Responses to CEC Data Requests: Nos. A1 through A123

Amended Application for Certification for HYDROGEN ENERGY CALIFORNIA (08-AFC-8A) Kern County, California

**RESPONSES TO DATA REQUESTS A1 THROUGH A123
FROM CALIFORNIA ENERGY COMMISSION (CEC)**

FIGURE A63-1

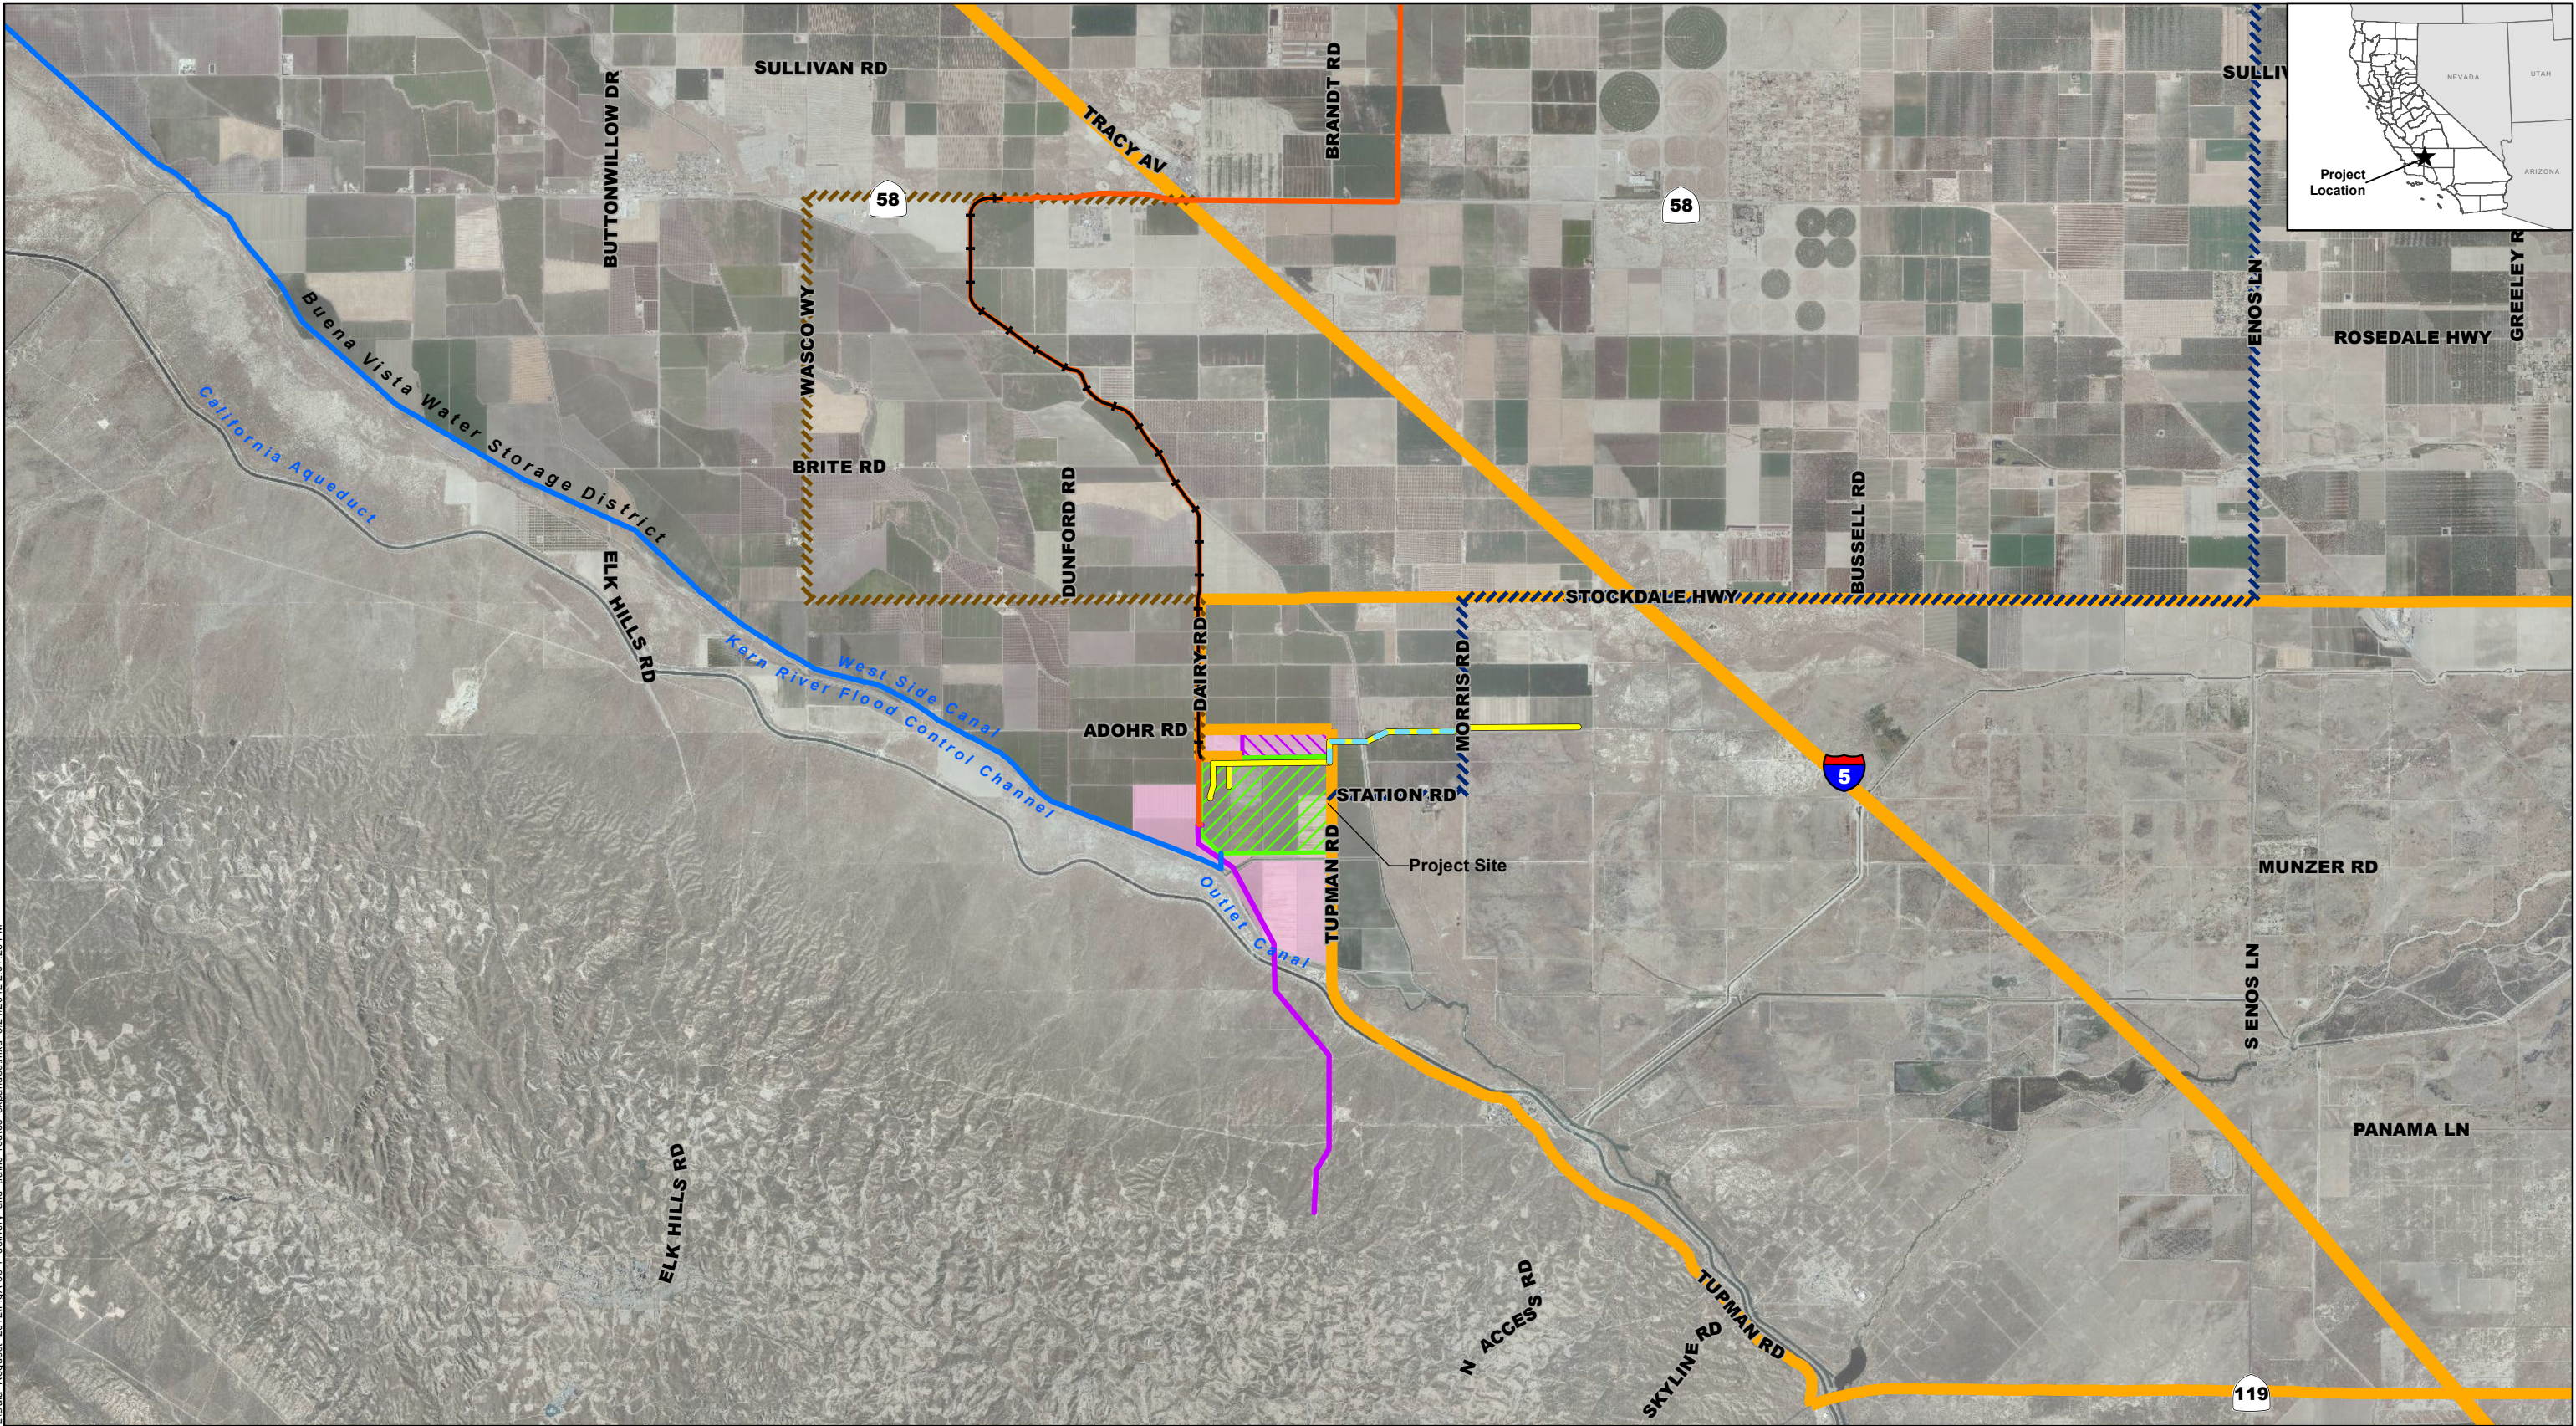
A63. Please provide a figure showing the product truck delivery routes, the 27-mile truck route from the Wasco coal transloading facility to the project site, and the construction traffic routes.

Figure A63-1 shows the routes for truck delivery and construction vehicles. Figure A63-2 shows the 27-mile truck route from the Wasco coal transloading facility to the Project Site.

FIGURE A84-1 (SHEET 1)

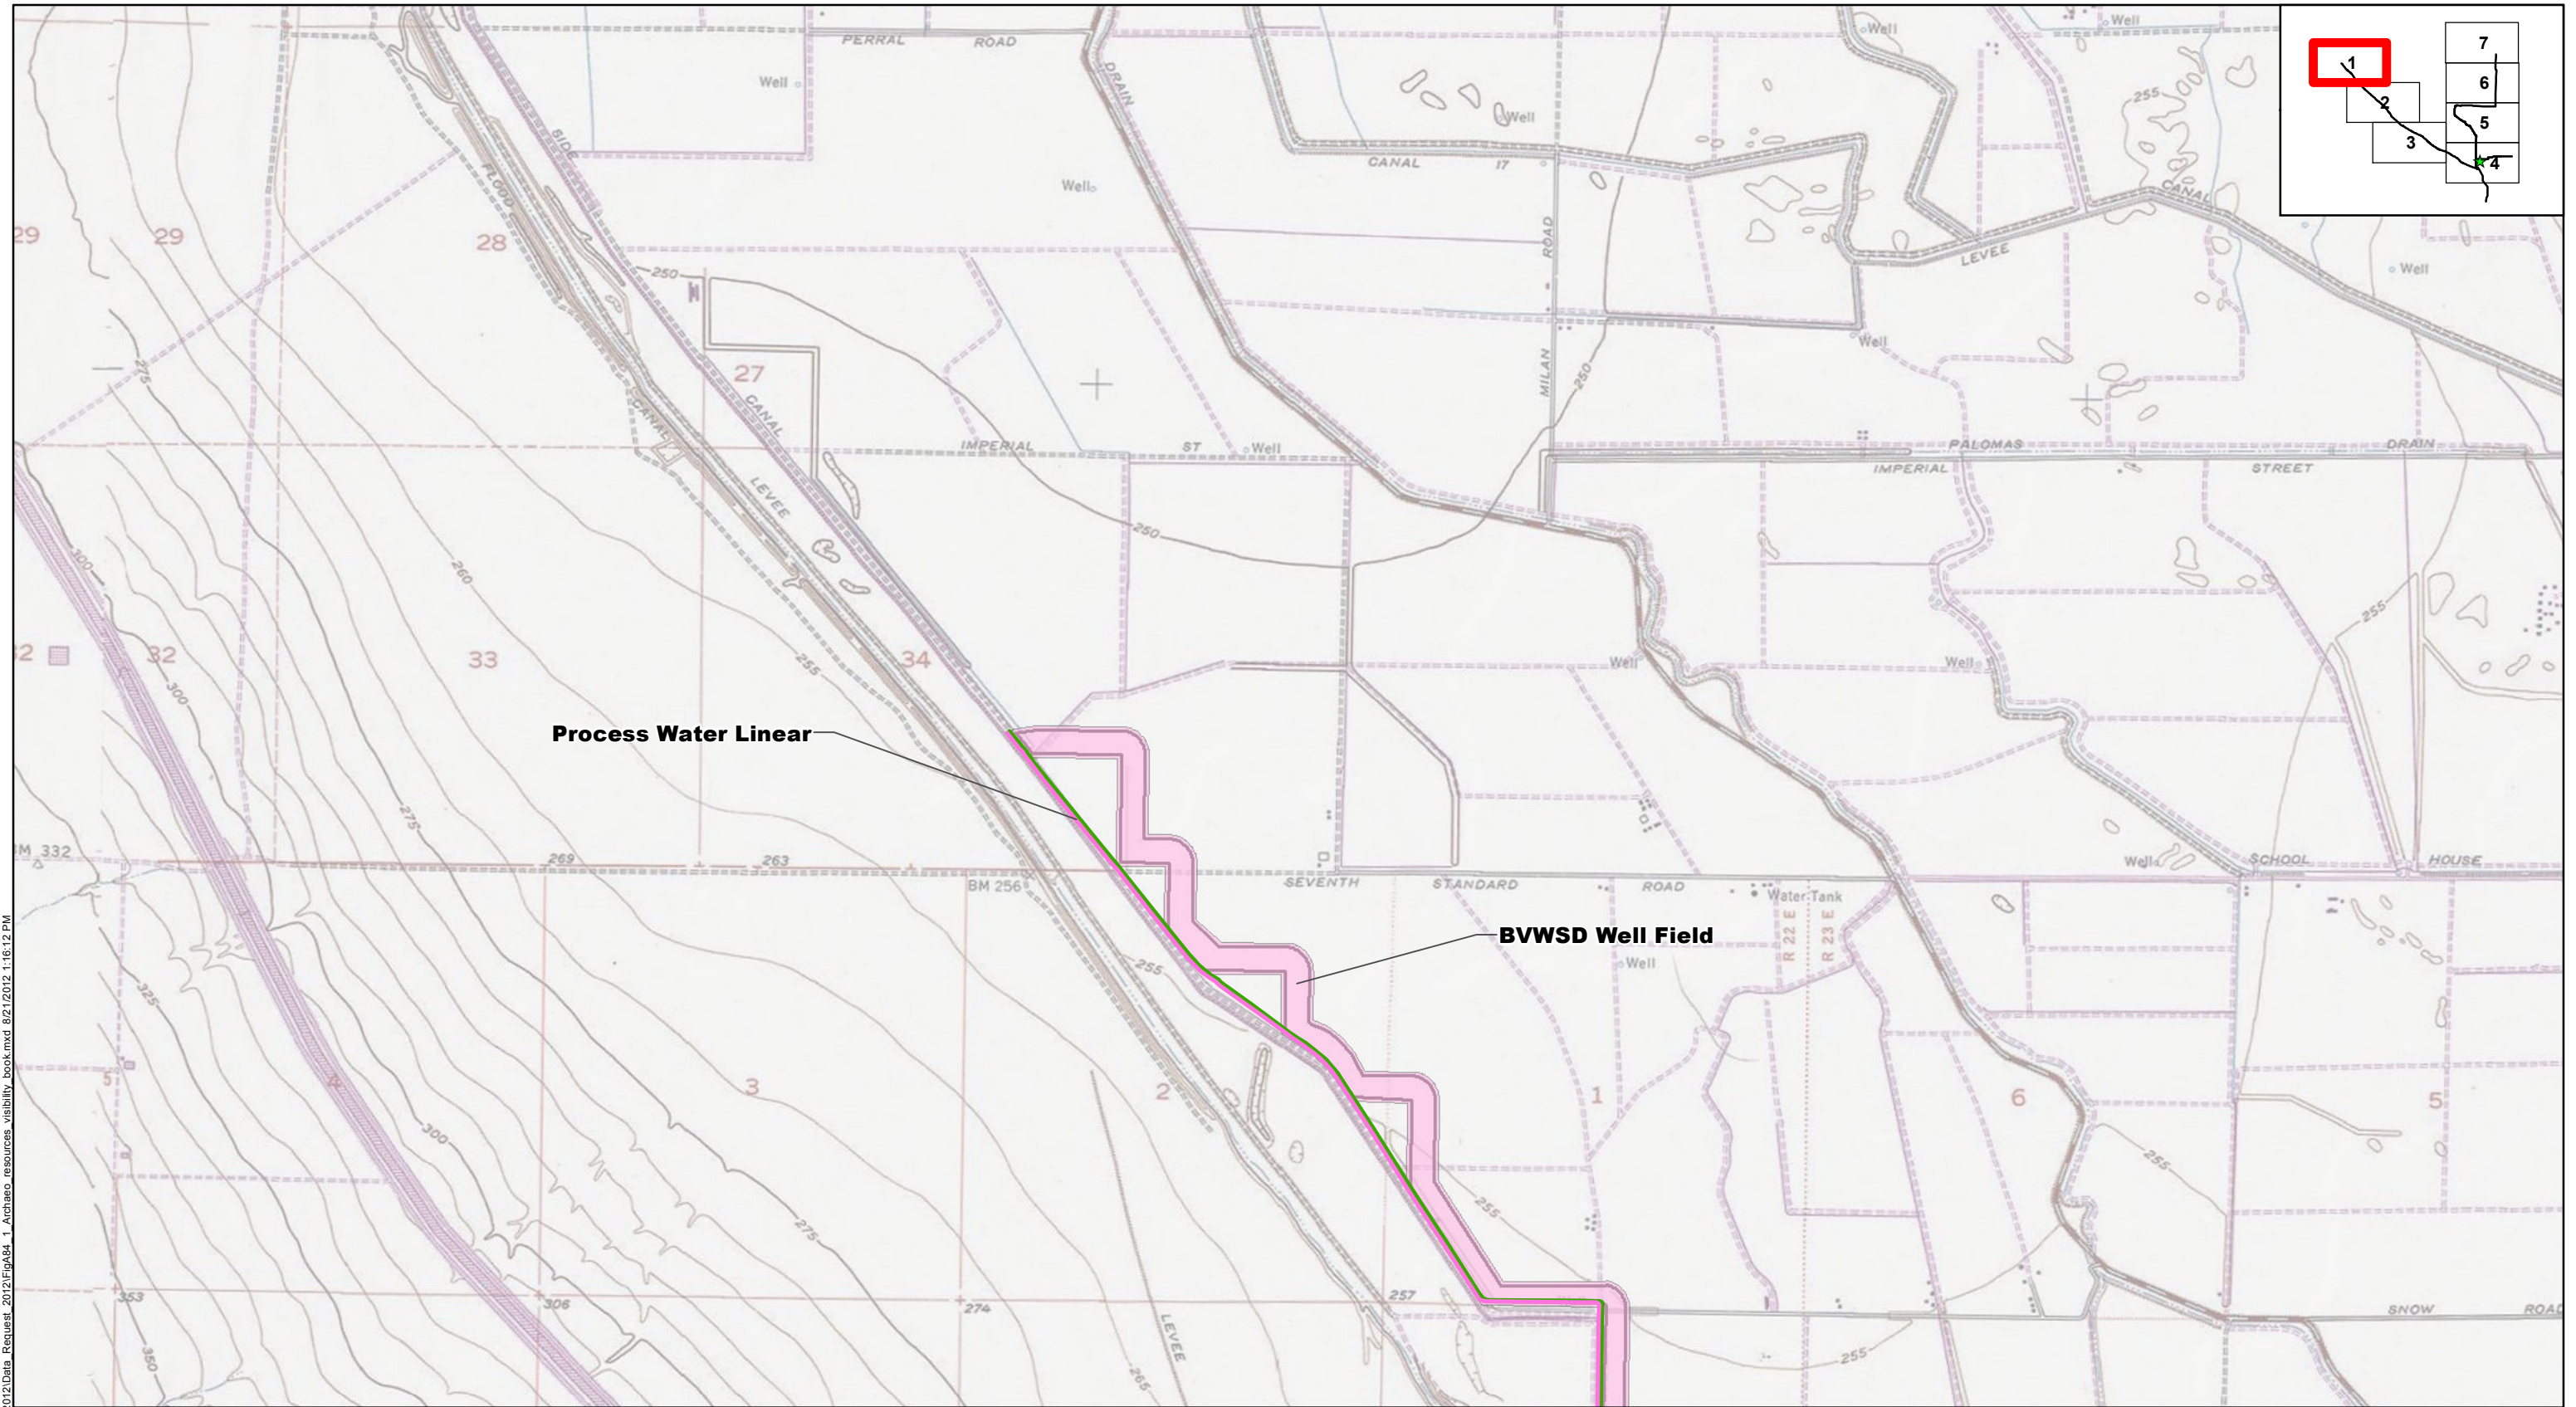
- a. The figures shall be based on 7.5-minute, U.S. Geological Survey topographic quadrangles at a scale of 1:24,000.**
- b. The figures shall show the project elements, archaeological resources study area boundary, any unsurveyed areas, and the ground-surface visibility throughout the archaeological resources study area.**

Figure A84-1 depicts all HECA Project components and the corresponding amount of surface visibility at the time archaeological surveys were conducted. Figure A84-1 is based on USGS 1:24,000 topographic quadrangles; includes the entire Archaeological Resources Study Area; and identifies areas that were not subject to pedestrian reconnaissance due to lack of access.
